RENESAS TECHNICAL UPDATE

Product Category	MPU/MCU		Document No.	TN-RX*-A176A/E	Rev.	1.00
Title	Supplementary Information on and Errata to the SD Slave Interface (SDSI), 12-Bit A/D Converter (S12ADFa) and Electrical Characteristics for the RX65N Group, RX651 Group		Information Category	Technical Notification		
Applicable Product	RX65N Group, RX651 Group	Lot No.	Reference Document	RX65N Group, RX651 Group User's Manual: Hardware Rev.1.00 (R01UH0590EJ0100)		
		All

This document describes the supplementary information and errata to sections I/O Registers, Interrupt Controller (ICUB), SD Slave Interface (SDSI), 12-Bit A/D Converter (S12ADFa), and Electrical Characteristics of the RX65N Group, RX651 Group User's Manual: Hardware, Rev.1.00.

Address(es): SDSI.FN1DATAR10 to SDSI.FN1DATAR163 0009 5800h to 0009 58FFh

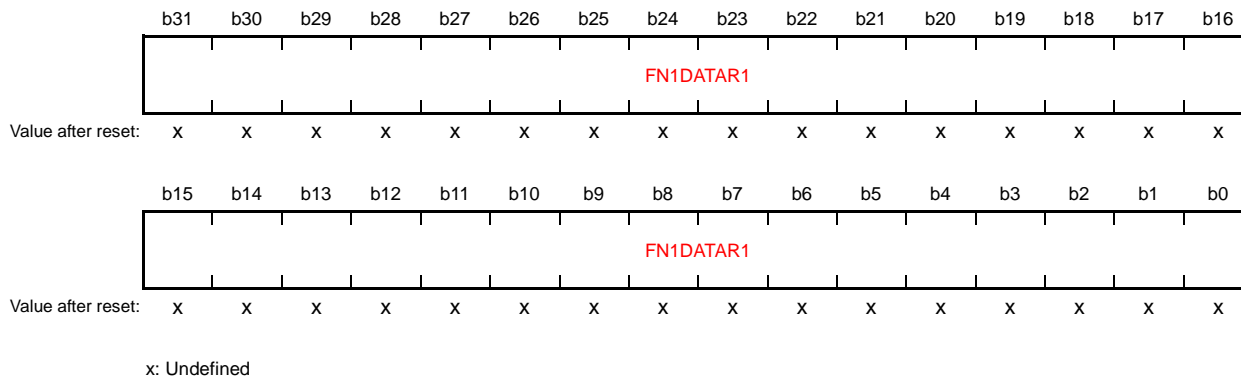
The bit charts and bit description tables in section 44.3.24, FN1 Data Register 1i (FN1DATAR1i) (i = 0 to 63), section 44.3.25, FN1 Data Register 2i (FN1DATAR2i) (i = 0 to 63), section 44.3.26, FN1 Data Register 3i (FN1DATAR3i) (i = 0 to 63), and section 44.3.29, FN1 Data Register 5i (FN1DATAR5i) (i = 0 to 255) are modified as follows.

The following bit chart and bit description table are of the FN1DATAR1i register, and the corresponding charts and tables in the other registers are modified in the same way.

Figure 44.2 Data Formats When Swapping the Data

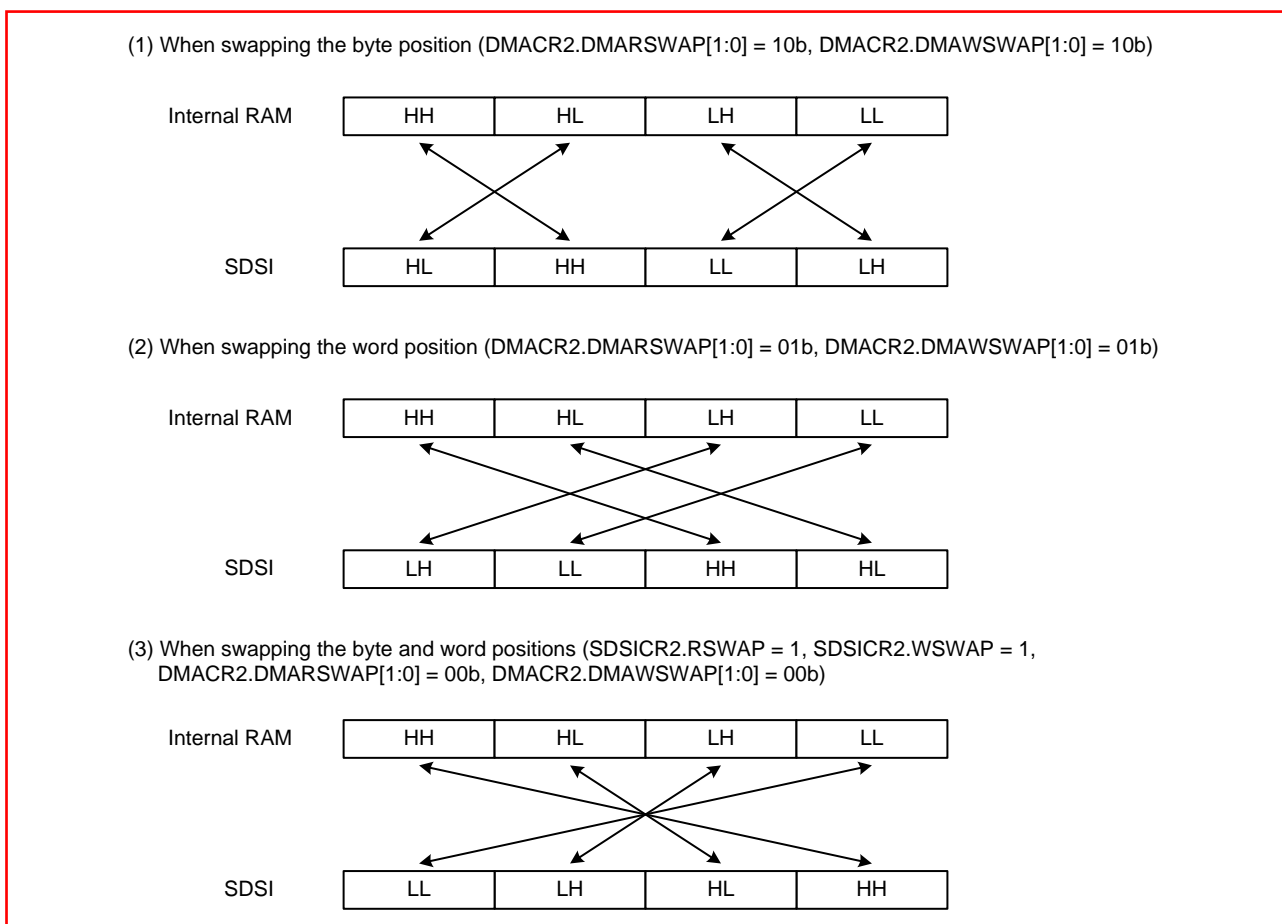
The following figure is added to section 44.4.2, SD Data Format.

Figure 44.2 shows the data format when selecting the data swapping.

Figure 44.2 Data Format

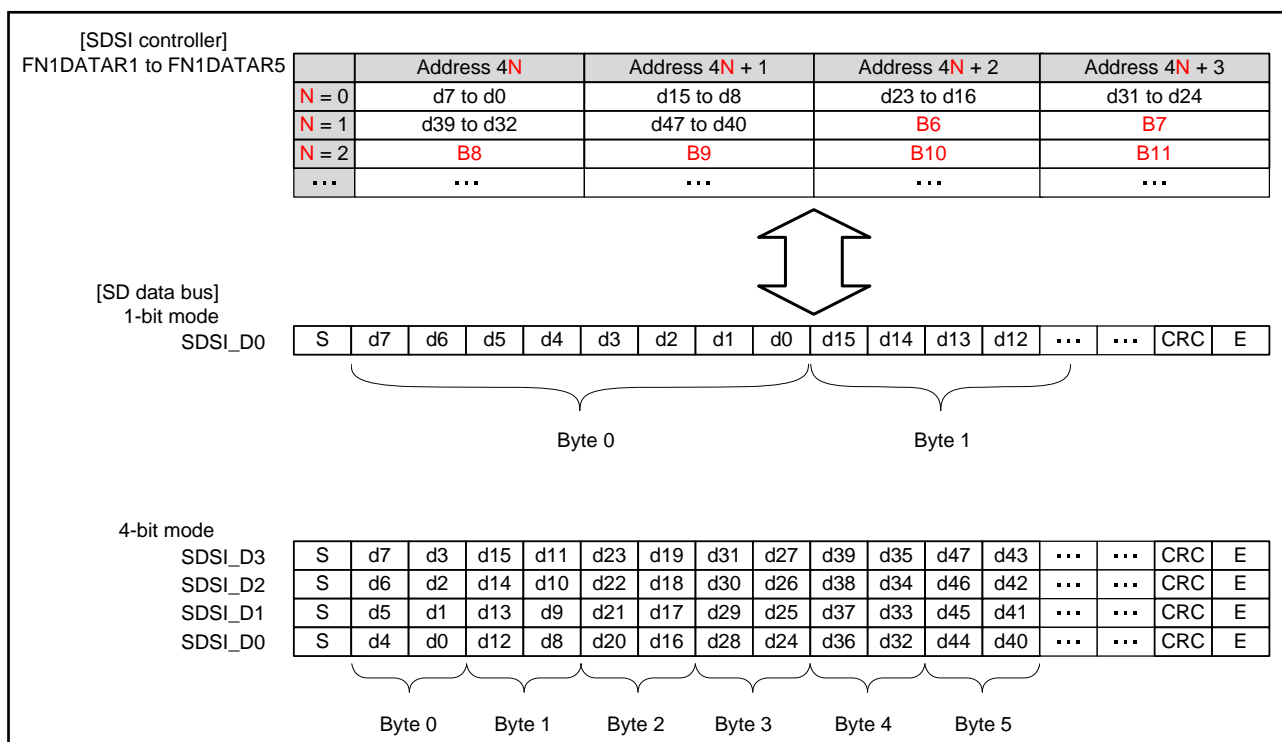
The descriptions of (1) When FN1 Data Register is used in section 44.4.2, SD Data Format are modified as follows.

Figure 44.2 shows how data are stored in the FN1DATAR registers 1 to 5 (FN1DATAR1 to FN1DATAR5) and the order of transfer of the data over the SD bus when these registers are used for data transfer. Consider the order of the transfer over the SD bus in access to the FN1DATAR registers. These registers can be accessed **in byte units by swapping the data.**

Figure 44.3 Data Format (Without **Swapping Data in Byte/Word units**)

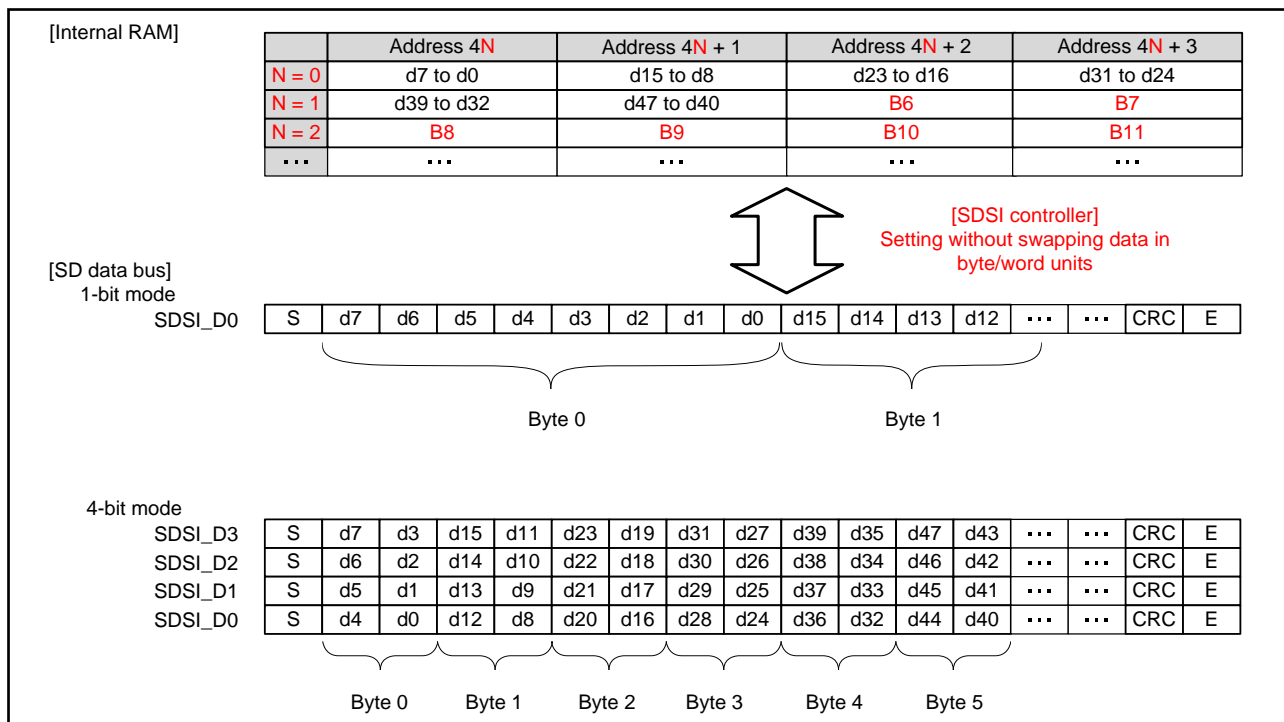
The descriptions of (2) When DMA transfer is used in section 44.4.2, SD Data Format are modified as follows.

Figure 44.3 shows the stored data of the internal RAM and order of the data transfer on the SD bus when data transfer with DMA transfer is performed.

Figure 44.4 Data Format (**with Swapping Data in Byte/Word Units**)

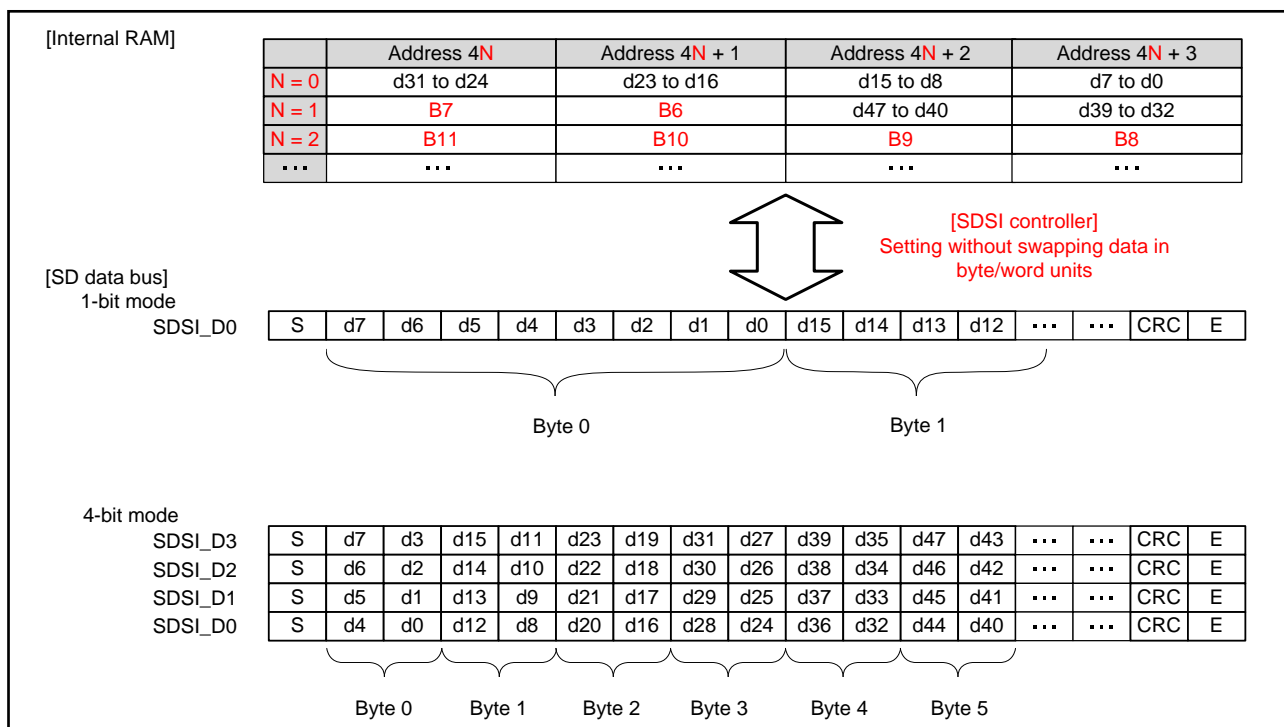
Figure 44.4 shows the order for the data transfer on the bus for swapping data in byte/word units.
